Access Compliance Report

Public Rights-of-Way

(Curb Ramps)

Intersection ID: 3871	Main Street: FOXBRIAR_TL	Cross Street: IVY_RIDGE_PL	Location:	N
ADA ID: 5721C6DD55CF	Ramp Type: Perp	Initial Pass/Fail: Fail	Overall Compliance: No	Severity Score: 21.25
Codes/Mitigation Info/Possible Solution		Field Measurements/Component Compliance

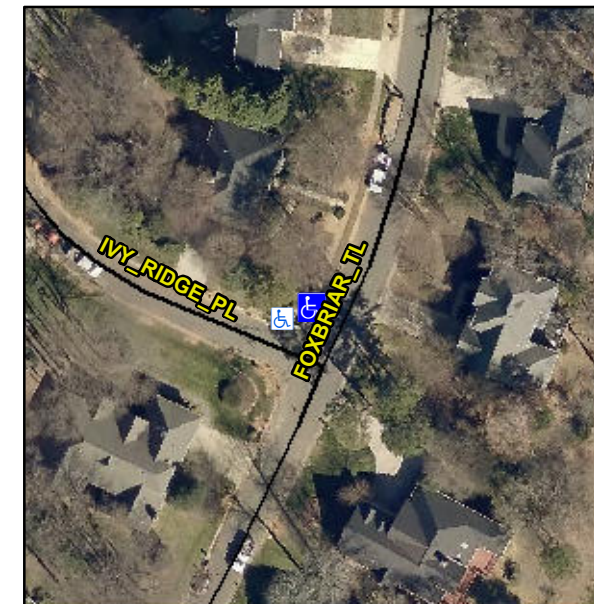
Not Found, R304.5.1, R304.2.2

Compliance	Description	Data	Compliance	Description	Data
N/A	Ramp Length (in)	48.5	No	Ramp Slope (%)	10.2
No	Ramp Width (in)	46.0	Yes	Ramp XSlope (%)	1.5
N/A	Flare Type LT	N/A	N/A	Flare Type RT	N/A
N/A	Flare Slope LT (%)	N/A	N/A	Flare Slope RT (%)	N/A
N/A	Flare Traversable LT?	N/A	N/A	Flare Traversable RT?	N/A
N/A	Landing Length (in)	N/A	N/A	DWS Provided?	N/A
N/A	Landing Width (in)	N/A	N/A	DWS Contrast?	N/A
N/A	Landing Slope (%)	N/A	N/A	DWS Length (in)	N/A
N/A	Landing X Slope (%)	N/A	N/A	DWS Full Width?	N/A
N/A	Landing Curb? (Y/N)	N/A	N/A	DWS Offset (in)	N/A
N/A	Shared Landing?	N/A			
N/A	Gutter Ponding?	N/A	N/A	Gutter Slope (%)	N/A
N/A	Gutter Lip Ht (in)	N/A	N/A	Gutter X Slope (%)	N/A
N/A	Painted X Walk1?	No	N/A	Painted X Walk2?	N/A
	X Walk 1 Direction	To SE		X Walk 2 Direction	N/A
N/A	X Walk 1 Width (in)	N/A	N/A	X Walk 2 Width (in)	N/A
	X Walk 1 Slope (%)	3.4		X Walk 2 Slope (%)	N/A
	X Walk 1 X Slope (%)	1.2		X Walk 2 X Slope (%)	N/A

Remove & Replace Entire Ramp.
